RENESAS TECHNICAL UPDATE

Product Category	MPU/MCU		Document No.	TN-RX*-A185A/E	Rev.	1.00
Title	Corrections to Descriptions for the P/E Suspend Command of Flash Memory in RX62N Group, RX621 Group, RX62T Group, and RX62G Group		Information Category	Technical Notification		
Applicable Product	RX62N Group, RX621 Group, RX62T Group, RX62G Group	Lot No. All	Reference Document	RX62N Group, RX621 Group User's Manual: Hardware Rev.1.40 (R01UH0033EJ0140) RX62T Group, RX62G Group User's Manual: Hardware Rev.2.00 (R01UH0034EJ0200)

Clearing conditions of the SUSRDY bit in section 38.2.5, Flash Status Register 0 (FSTATR0) are corrected as follows.

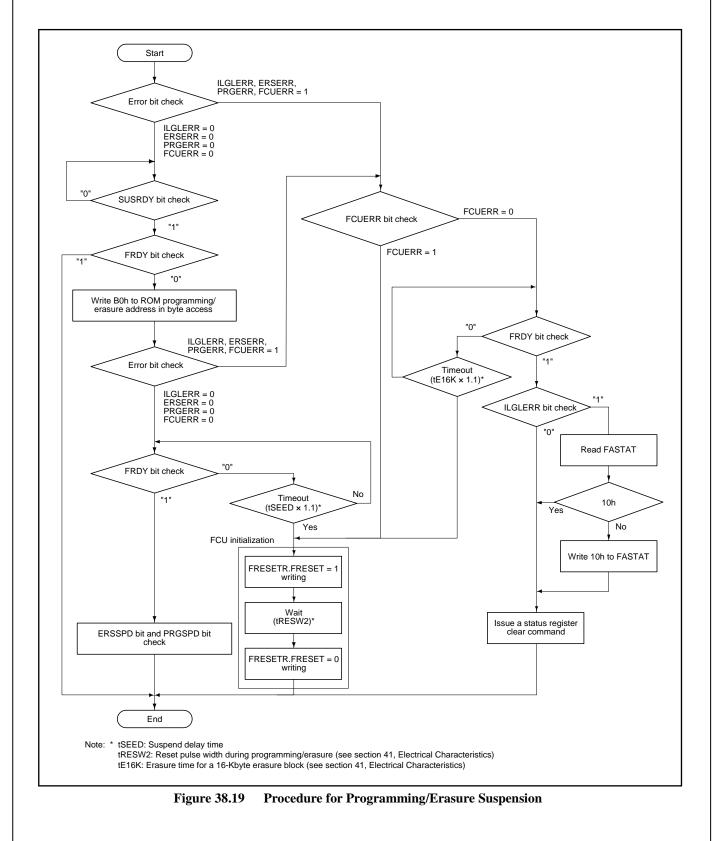
- The FCU has accepted a P/E suspend command.
- During programming/erasure process, the FCU enters the command-locked state.

- The FCU has accepted a P/E suspend command.
- During programming/erasure process, the FCU enters the command-locked state.
- When programming/erasure process has been completed.

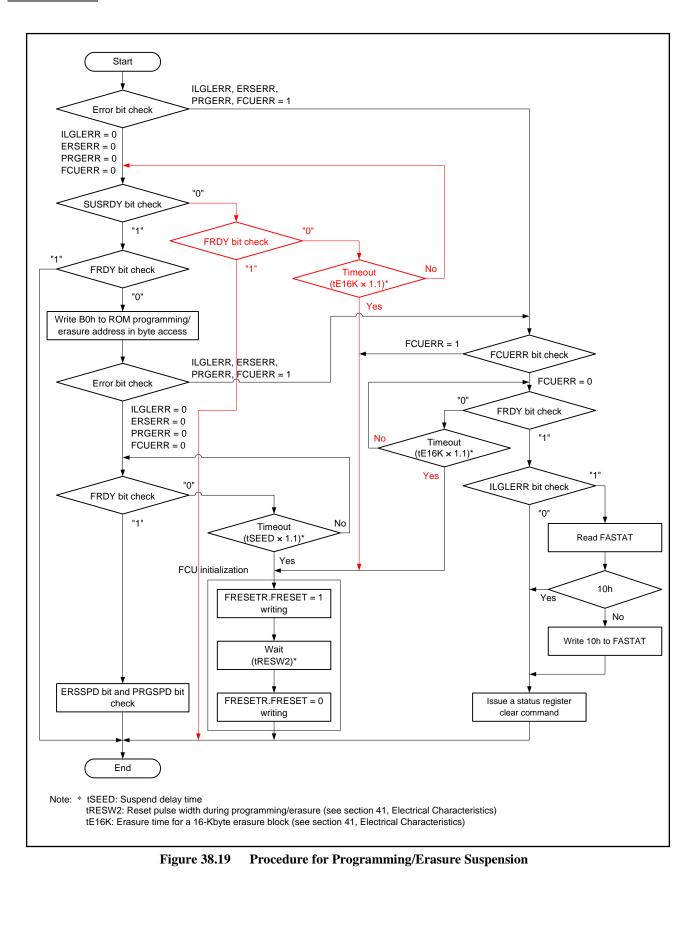
In Figure 38.19, Procedure for Programming/Erasure Suspension, a processing flow never escapes from the loop for a checking procedure if the programming/erasure processing completed before checking the SUSRDY bit. Therefore, a timeout processing and a breaking processing when the FRDY bit is 1 are to be added.
